ADDENDUM NO. 03

**Kalamazoo Public Schools Loy Norrix High School Mechanical Improvements
606 East Kilgore Road
Kalamazoo, MI 49001**

ADDENDUM NO. 3

PROJECT: Loy Norrix High School Mechanical Improvement D Wing
606 East Kilgore Road
Kalamazoo, MI 49001

SHEET NUMBER
AD 101D1
23-637.00

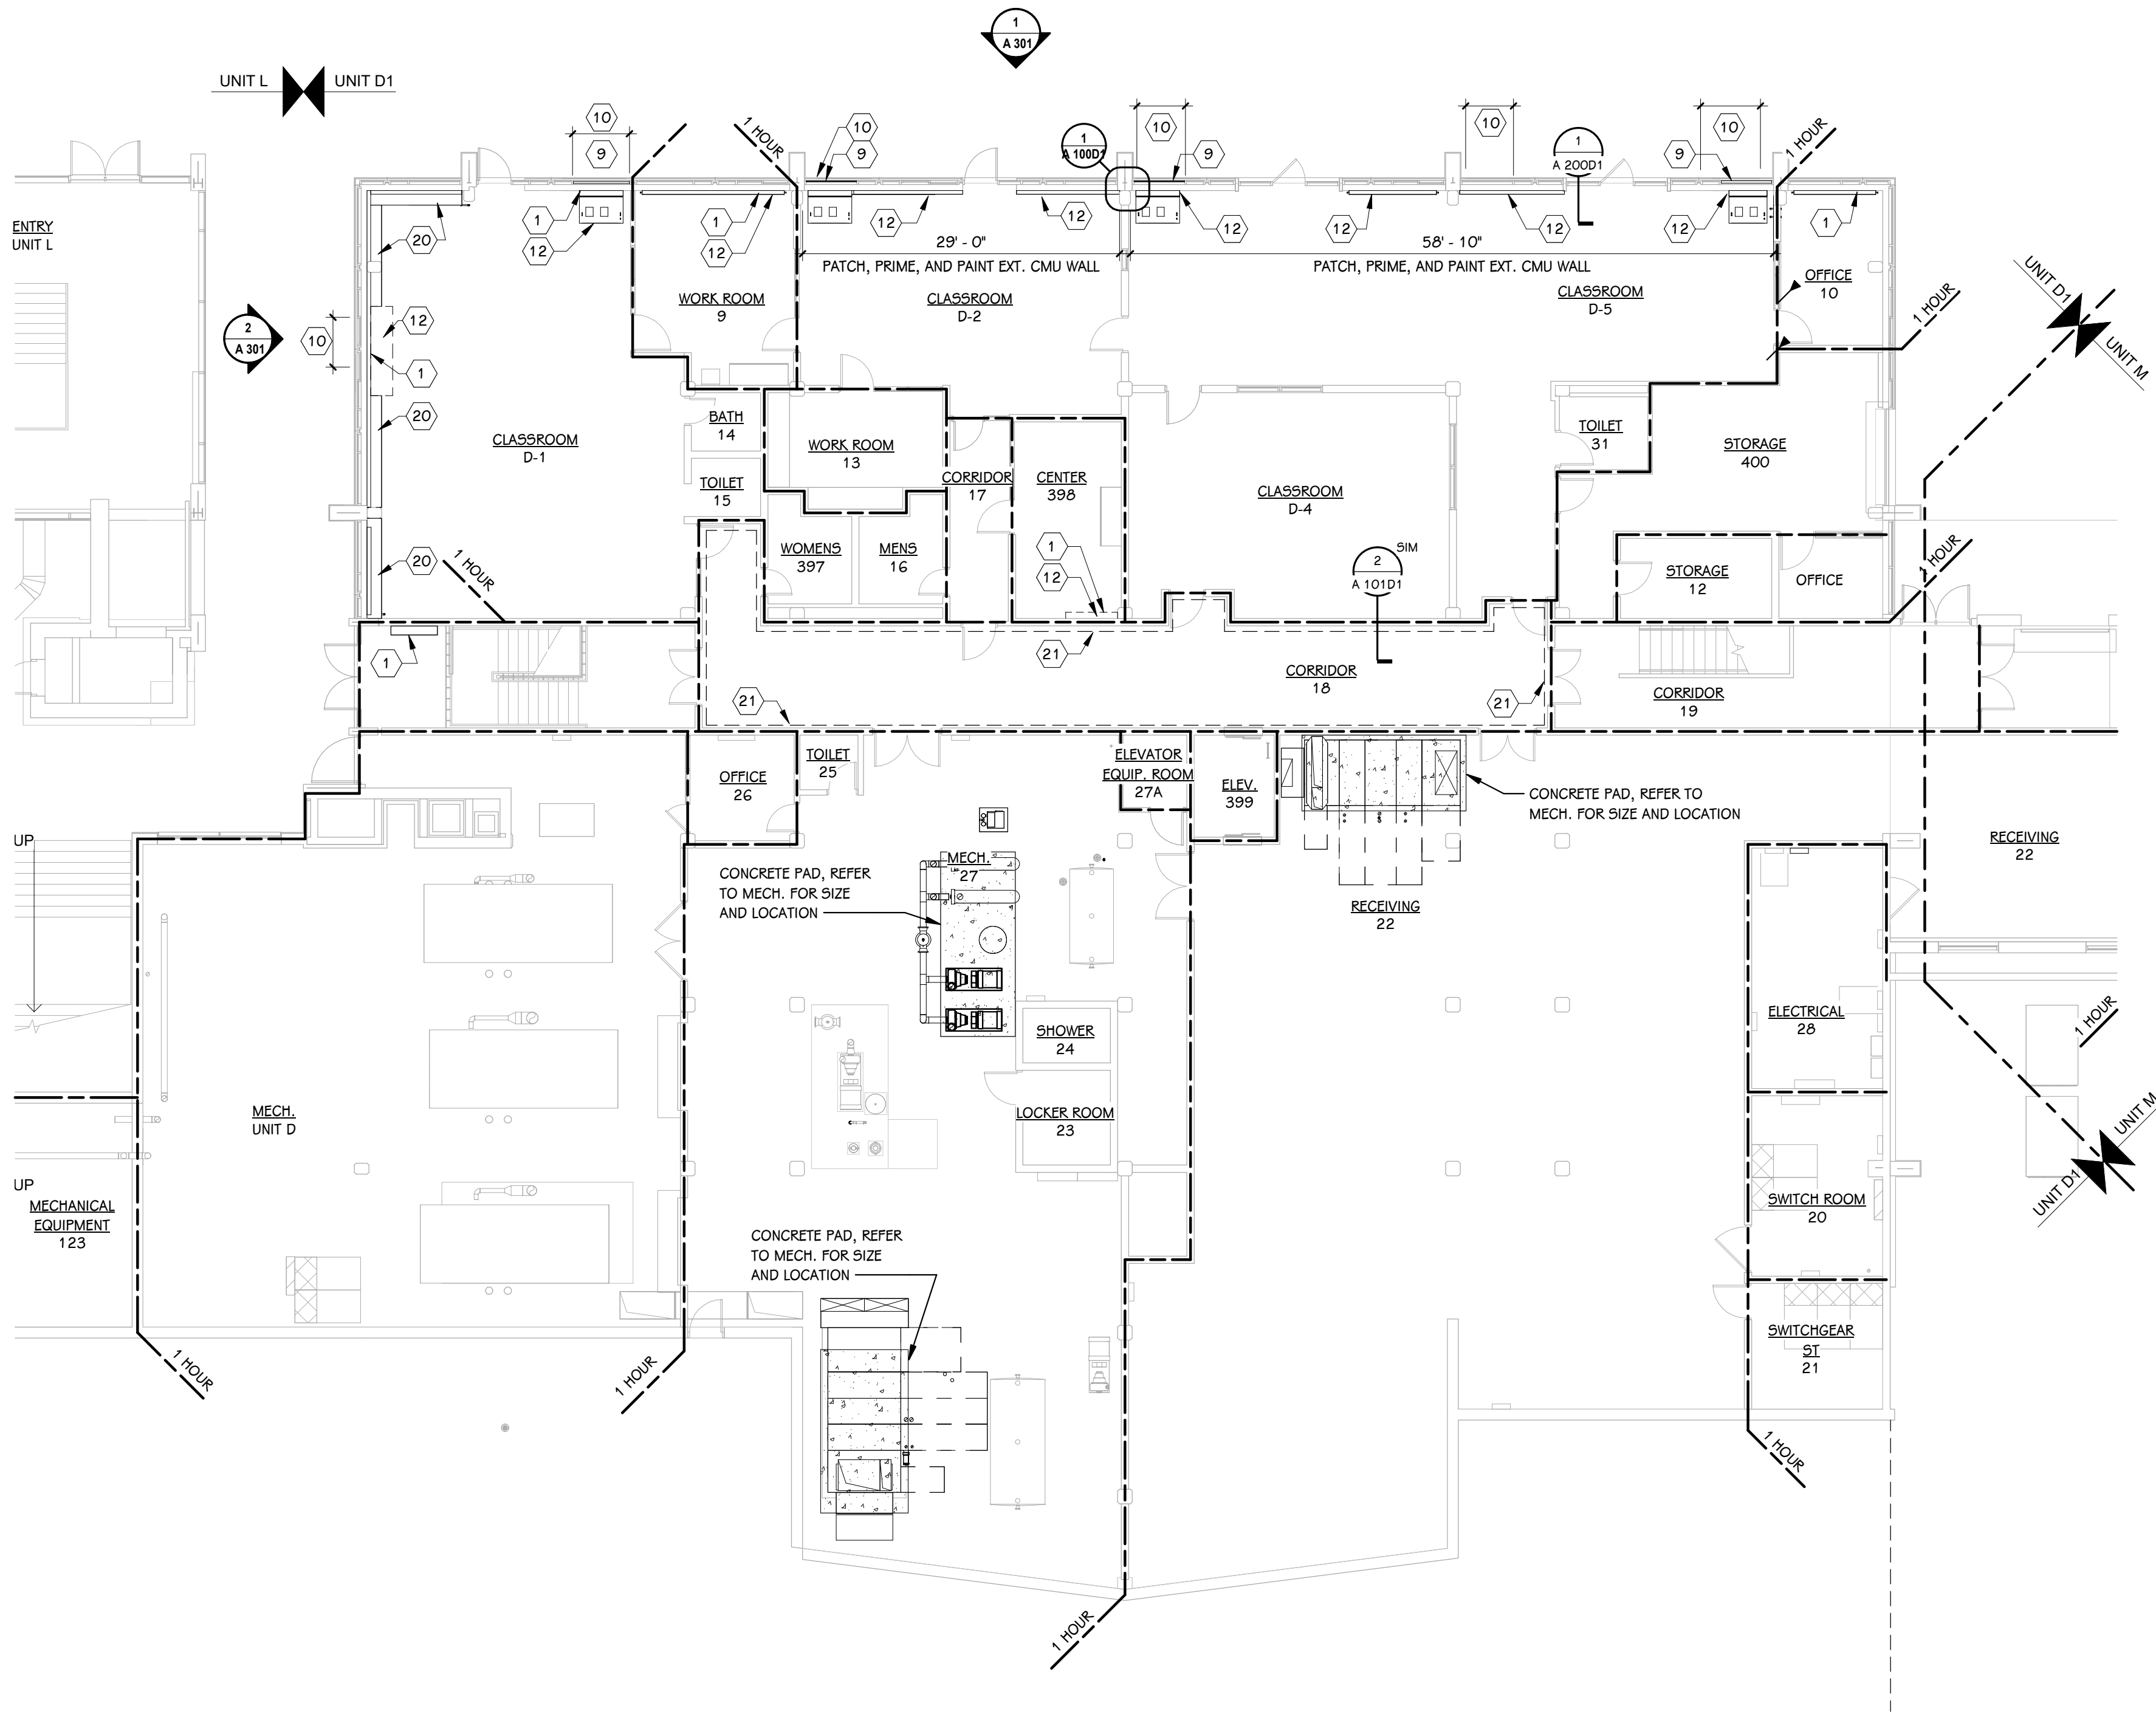
ADD-3 Item No. D-2 - Clarified Ceiling Wood Trim Demo Locations

Updated and clarified locations where wood trim pieces at ceiling need to be removed and salvaged.

SHEET NUMBER
A 100D1
23-637.00

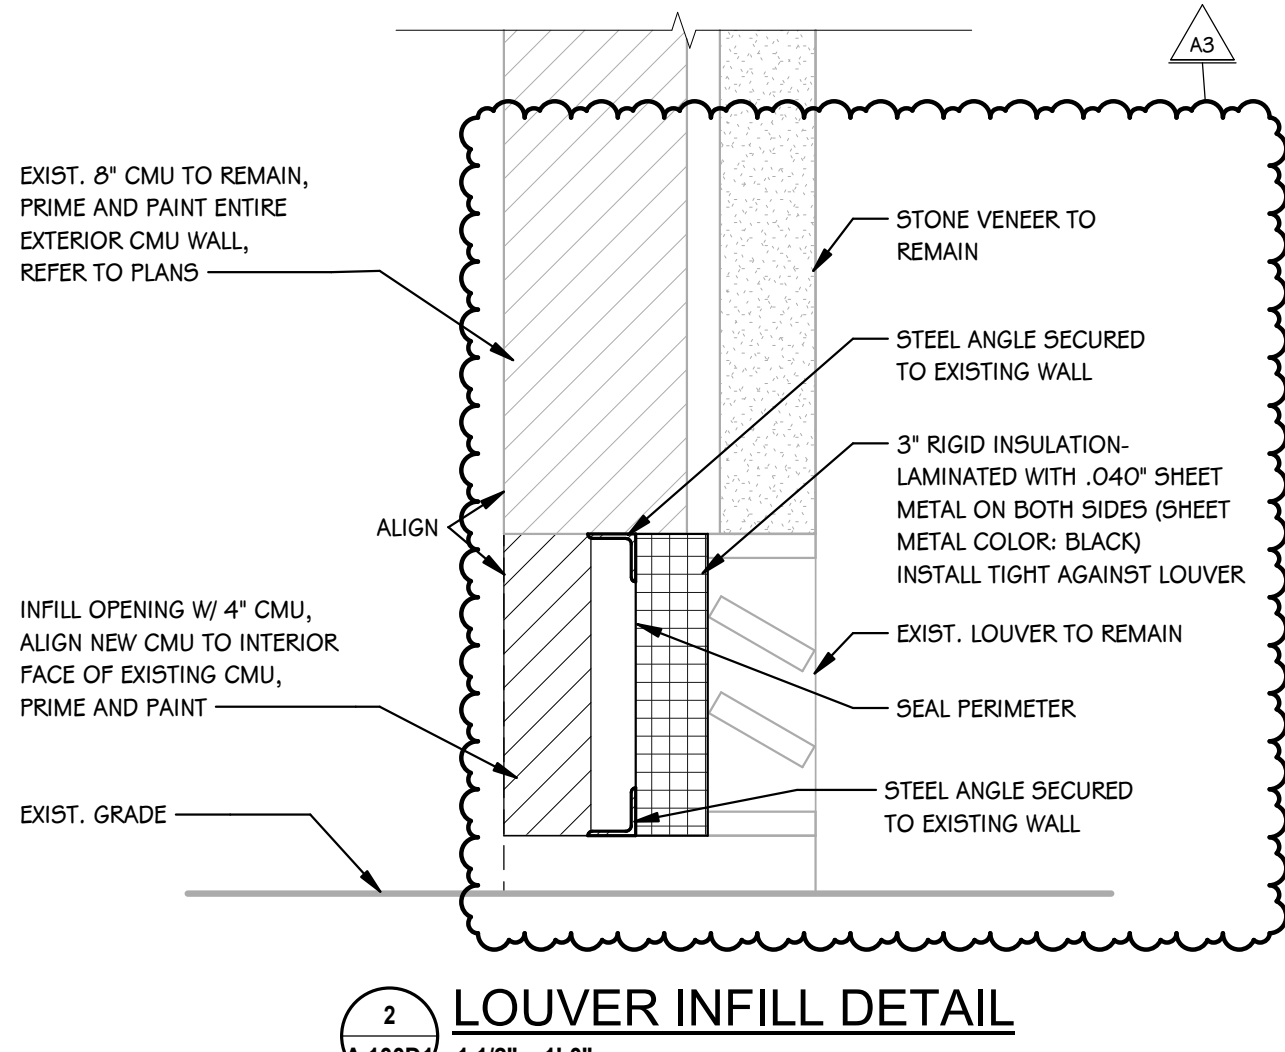
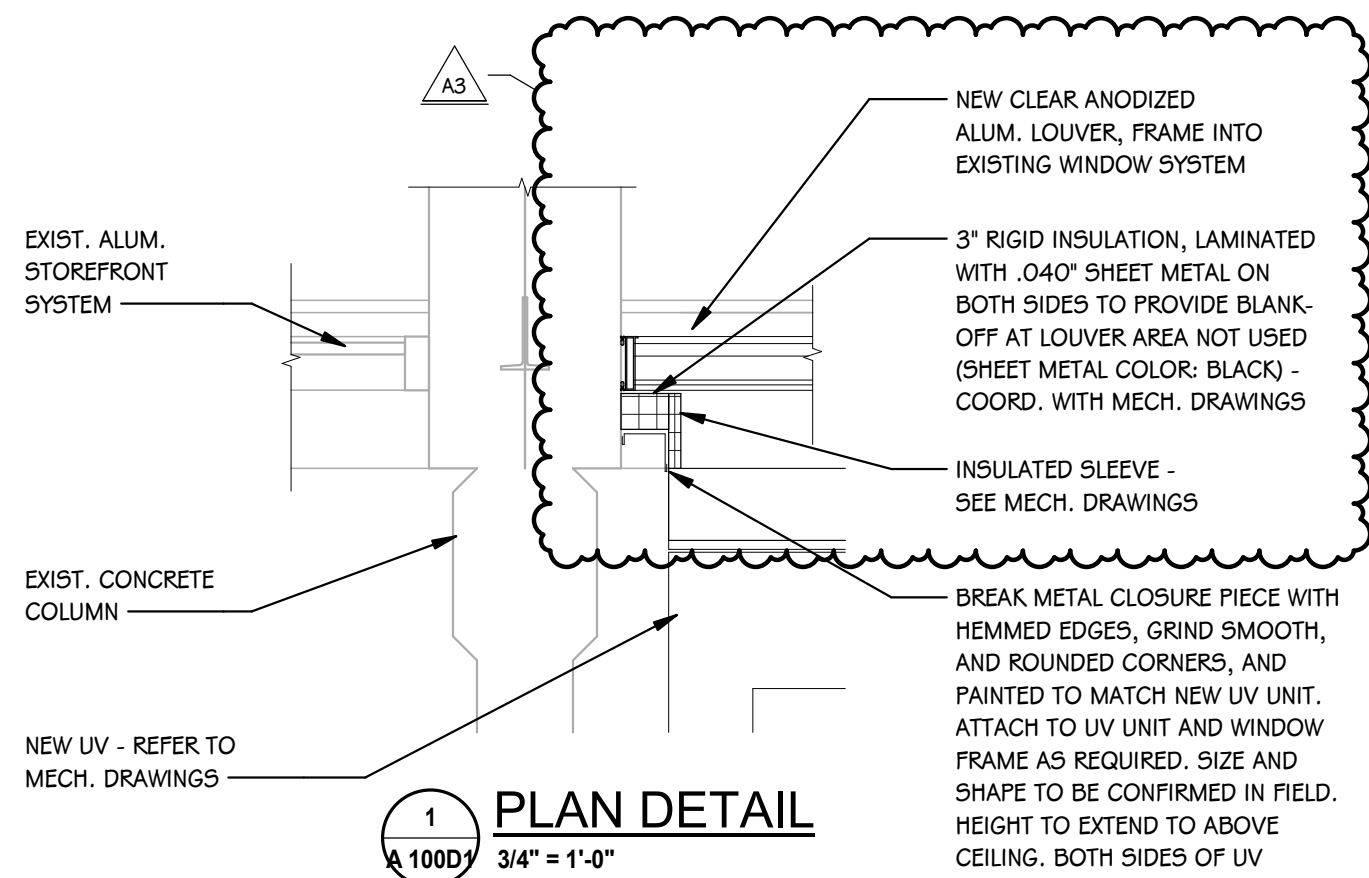
ADD-3 Item No. D-3 - Updated Louver Details

Clarified verbiage to specify material assembly for louver blank off panel.

- IN EXISTING LOUVER OPENING INSTALL 3" INSULATED METAL PANEL (BLACK) TIGHT AGAINST LOUVER AND TIGHT IN OPENING. SECURE IN PLACE AND CAULK ALL SIDES. AT INSIDE FLUSH WITH INTERIOR FACE OF EXISTING CMU WALL ADD 4" CMU INFILL TOOTH IN ALL SIDES.
